Re: LFPCN41495 - Littelfuse SOD-123FL Package TPSMF4Lxx Auto TVS 1st assembly & test source transfer to new location and 2nd assembly & test source approval

PCN Report

Prepared By : Tianhua Wang-Product Engineer,
 Ada Du-Sr. OSAT Engineer,
Date : 11/8/2023
Device : SOD-123FL Package Product
Revision : 1

4.1 Packing Material

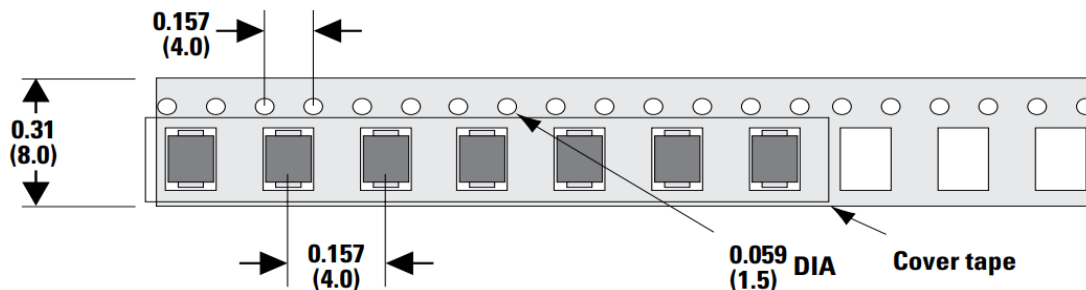
- Existing 1st Source will be transferred from current location to new location. No Packing changes.
- New adding 2nd Source

4.2 Tape Dimension

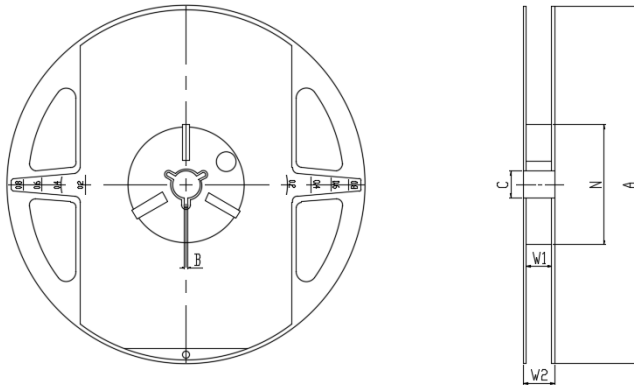
Source	Tape Dimension				Changed?
	W	D0	P0	P1	
1 st Source(new location)	8.00+0.3 -0.1	1.50+0.1	4.00±0.10	4.00±0.10	No
2 nd Source	8.00±0.15	1.55±0.15	4.00±0.15	4.00±0.15

Internal Remark: Bold Dimension which shows on datasheet has no changes. No need update datasheet

4.3.1 7inch Reel Dimension:

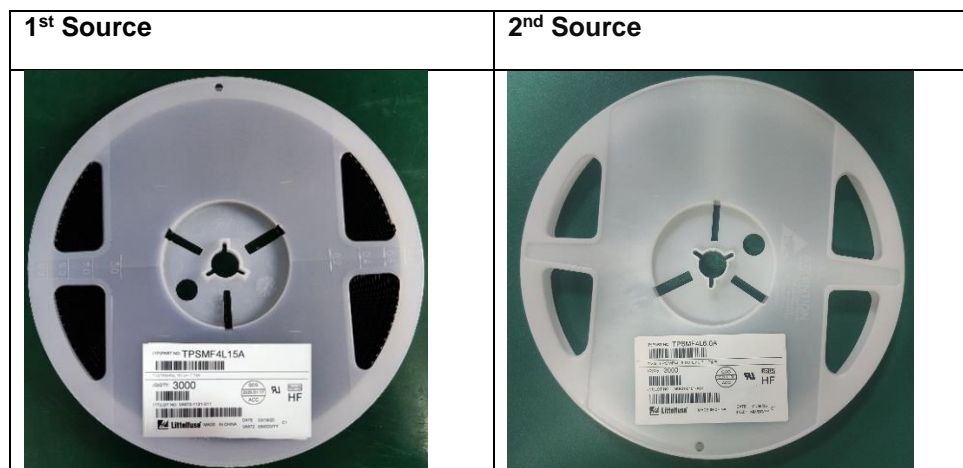
Source	Reel Dimension(mm)				
	A	N	W1	W2	C
1 st Source	178±1	60±0.1	9±0.3	11±1.0	13±0.2
2 nd Source	178±1	60.5±0.5	9.2±0.5	11±0.5	13±0.5

- Existing 1st Source will be transferred from current location to new location. No reel changes.
- New adding 2nd Source

Internal Remark: Bold Dimension which shows on datasheet has no changes. No need update datasheet

4.4 Label on Reel and Pizza Box

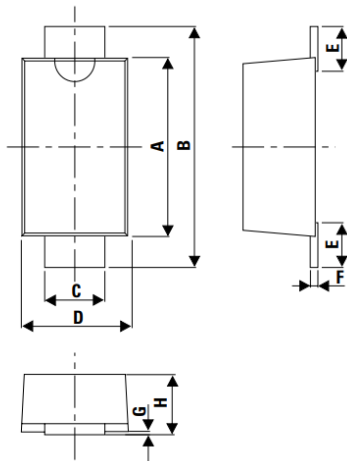
- Existing 1st Source will be transferred from current location to new location. No Label changes.
- New adding 2nd Source
